UNITED STATES PATENT AND TRADEMARK OFFICE

APPLICATION NO.	FILING DATE	FIRST NAMED INVENTOR	ATTORNEY DOCKET NO.	CONFIRMATION NO.
10/025,904	12/26/2001	Yong Ik Bang	8733.525.00	7612
30827	7590	07/27/2004		
MCKENNA LONG & ALDRIDGE LLP 1900 K STREET, NW WASHINGTON, DC 20006				
			EXAMINER RUDE, TIMOTHY L	
			ART UNIT 2883	PAPER NUMBER

Office Action Summary

DETAILED ACTION

FIG. 1

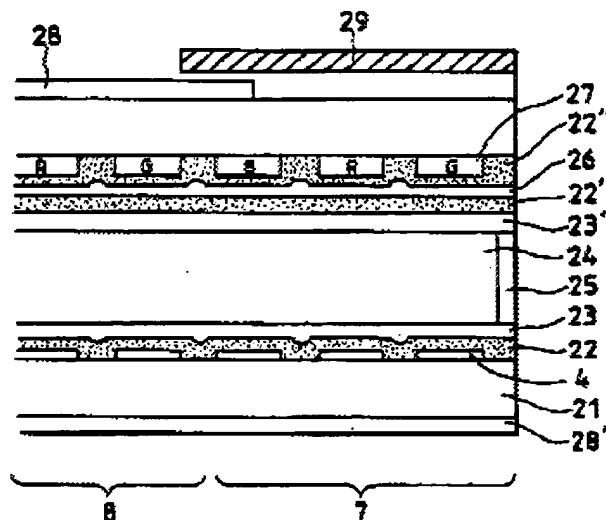
As to claim 1, Shimada discloses (Title, Abstract, entire patent) a liquid crystal display (LCD) panel comprising:
a first substrate provided with a plurality of gate, 2, and data, 8, lines, the gate lines being arranged to cross the data lines to define a plurality of pixel regions in a matrix arrangement; a second substrate provided with a black matrix layer (col. 5, lines 50-60) to shield portions other than the pixel regions from light; and liquid crystal layer injected between the first and second substrates, wherein the pixel regions in a peripheral portion of the matrix arrangement have an aperture ratio lower than that of the pixel

regions in other portions of the matrix arrangement (col. 2, lines 29-42 and col. 6, lines 35-45) in the example where the black matrix overlaps the pixel electrodes, 11.
